RE: J.W. Brendle Drain, Stanford Park Section 2B Arm

Re: JW Brendle Drain: Stanford Park Section 2B

During construction, changes were made to the drain, which will alter the plans submitted with my report for this drain-dated May 15, 2006. The report was approved by the Board at the hearing held August 28, 2006. (See Drainage Board Minutes Book 9, Pages 412-415)
The changes are as follows:

STORM PLAN & PROFILES
STANFORD PARK SECTION 2B
CARMEL INDIANA

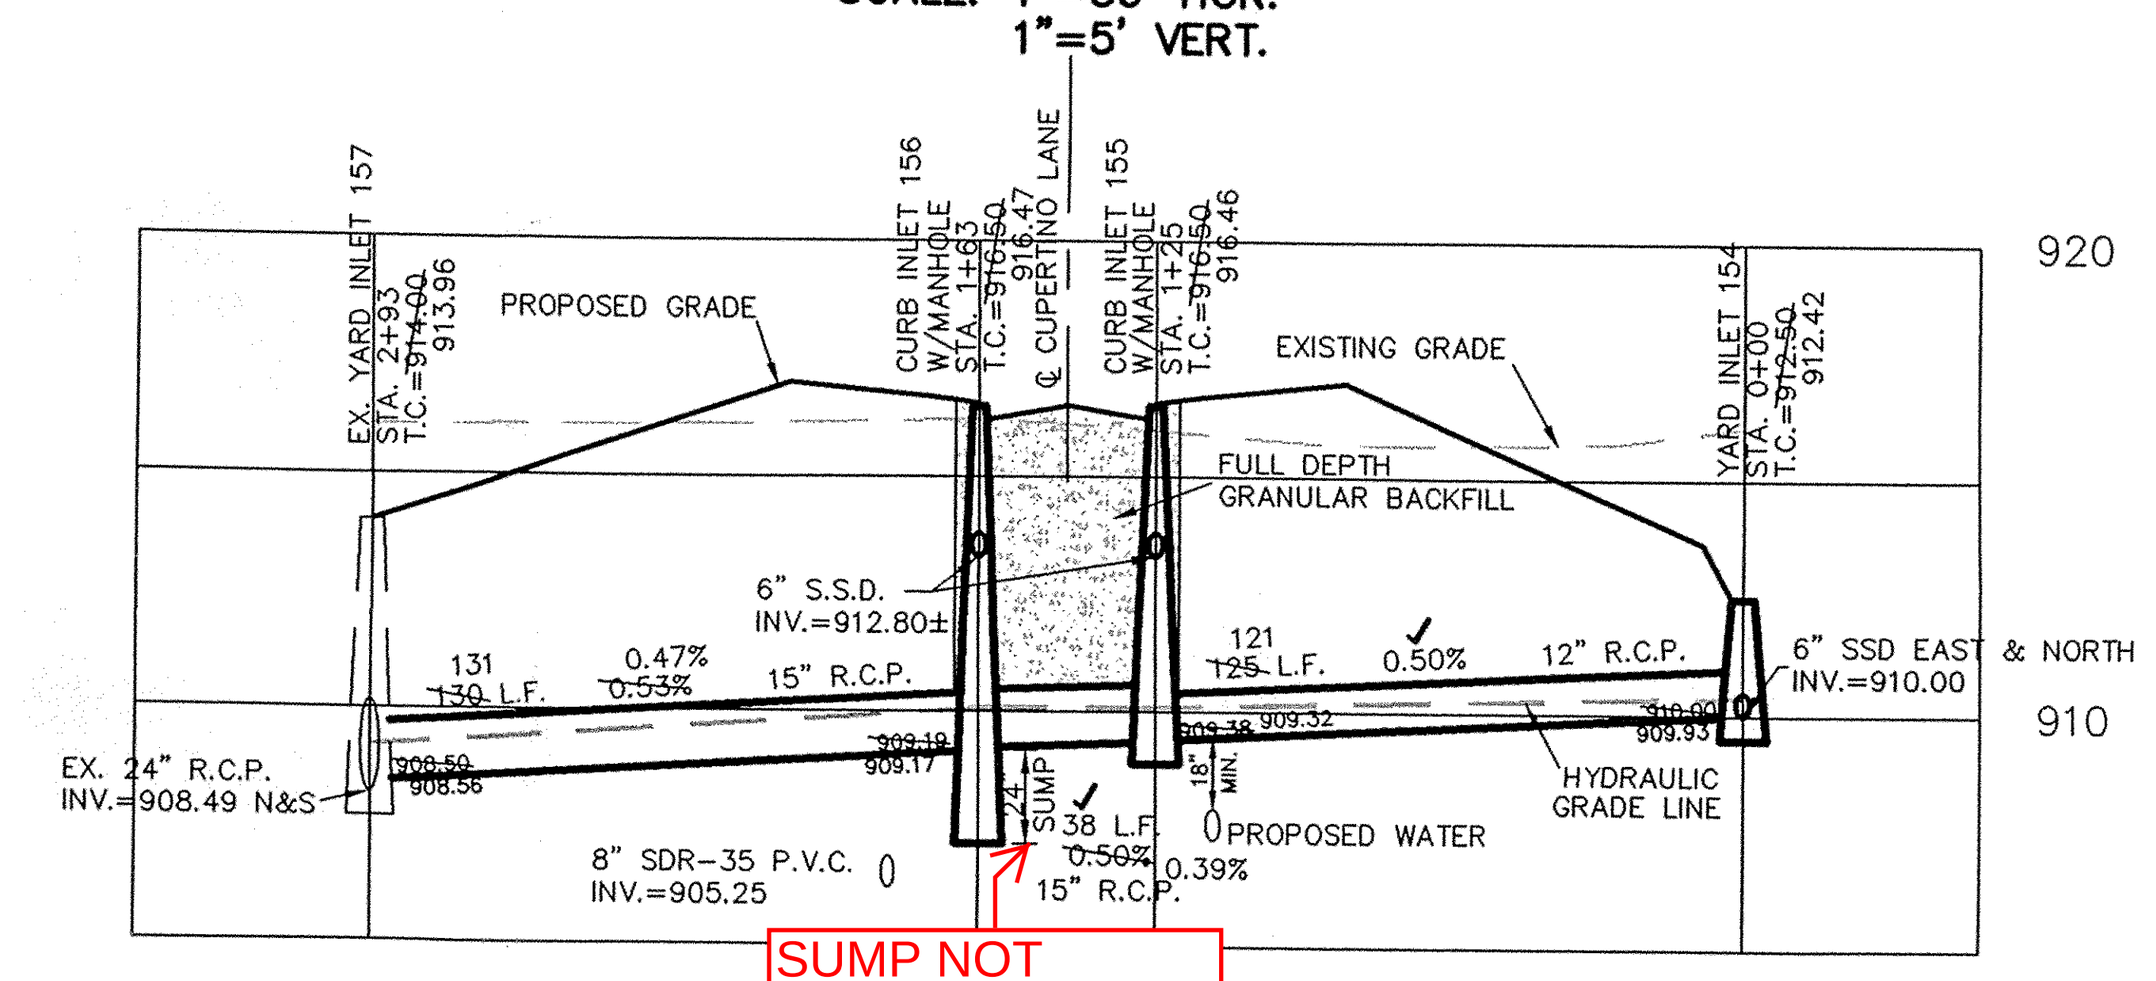
SUMP NOT INSTALLED PER INSPECTOR 2-11-2014

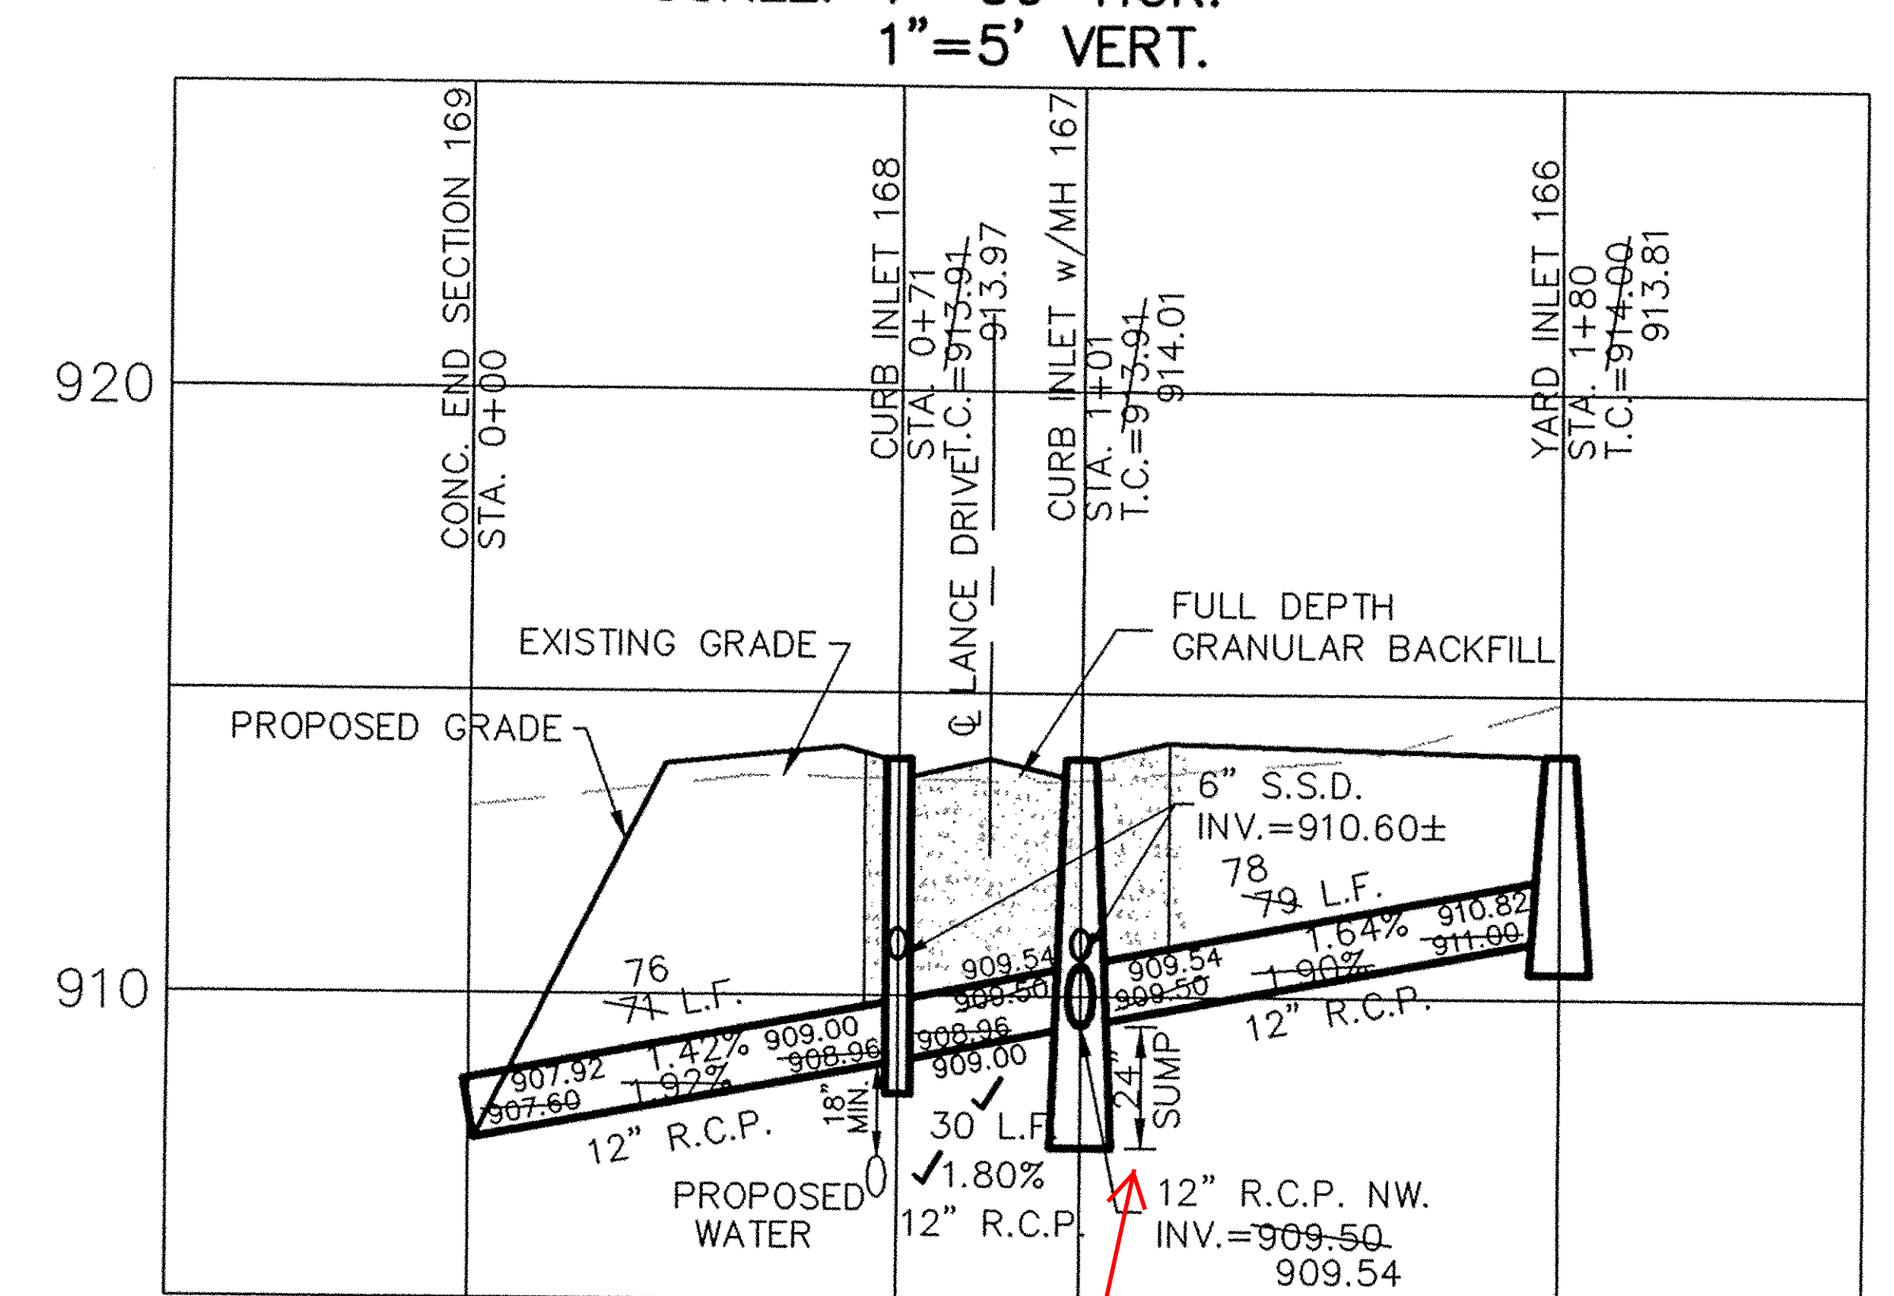
NO SUMP PER INSPECTOR 3-6-2012
